# Access Compliance Report

## Public Rights-of-Way

### (Curb Ramps)

Intersection ID: 48568	Main Street: BRAMBLE RIDGE CT	Cross Street: SALAMANDER RUN LN	Location: SW
ADA ID: 9246B6DBAA83	Ramp Type: PerpDiag	Initial Pass/Fail: Pass	Overall Compliance: No
Severity Score: 0			
Codes/Mitigation Info/Possible Solution		Field Measurements/Component Compliance

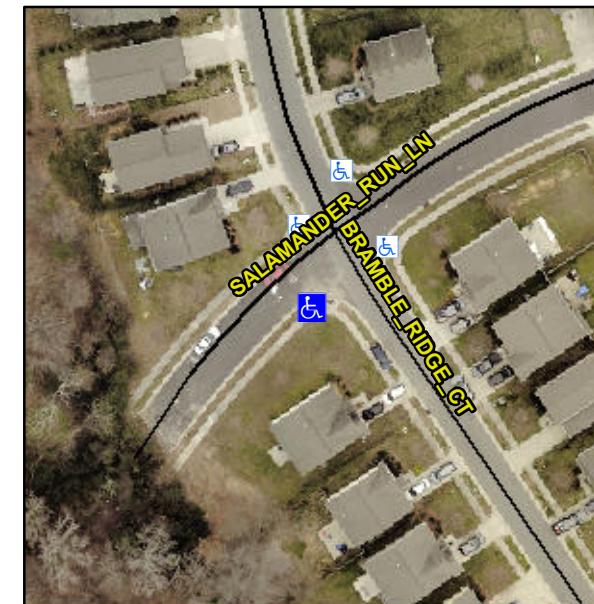
**Not Found, R304.2.1, R302.7**

Compliance	Description	Data	Compliance	Description	Data
N/A	Ramp Length (in)	47.5	Yes	Ramp Slope (%)	7.7
Yes	Ramp Width (in)	48.0	Yes	Ramp XSlope (%)	0.6
N/A	Flare Type LT	Sloped	N/A	Flare Type RT	N/A
N/A	Flare Slope LT (%)	0.9	N/A	Flare Slope RT (%)	0.8
N/A	Flare Traversable LT?	No	N/A	Flare Traversable RT?	No
No	Landing Length (in)	46.5	Yes	DWS Provided?	Yes
Yes	Landing Width (in)	80.0	Yes	DWS Contrast?	Yes
Yes	Landing Slope (%)	1.8	Yes	DWS Length (in)	24.5
Yes	Landing X Slope (%)	1.8	Yes	DWS Full Width?	Yes
N/A	Landing Curb? (Y/N)	No	Yes	DWS Offset (in)	0.0
N/A	Shared Landing?	No			
No	Gutter Ponding?	Yes	Yes	Gutter Slope (%)	4.6
Yes	Gutter Lip Ht (in)	0.0	Yes	Gutter X Slope (%)	1.9
N/A	Painted X Walk1?	No	N/A	Painted X Walk2?	No
	X Walk 1 Direction	To NE		X Walk 2 Direction	To N
N/A	X Walk 1 Width (in)	N/A	N/A	X Walk 2 Width (in)	N/A
	X Walk 1 Slope (%)	1.4		X Walk 2 Slope (%)	1.1
	X Walk 1 X Slope (%)	1.3		X Walk 2 X Slope (%)	0.2

N/A	Ramp inside XWalk1?	N/A	N/A	Ramp inside XWalk2?	N/A
	Road Slope (%)	0.4	N/A	Clear Space?	Yes
	Road X Slope (%)	1.2	N/A	Clear Space to XWalk (in)	N/A
Yes	Any Obstructions?	No	Yes	Storm Grate/Utility Hazard?	No
	Obstruction Type			Storm Grate/Utility Type	
		N/A			N/A
			Yes	Surface Condition? (G/P)	Good

**Remove & Replace Curb Ramp With Two New Directional Ramps or Equivalent.**
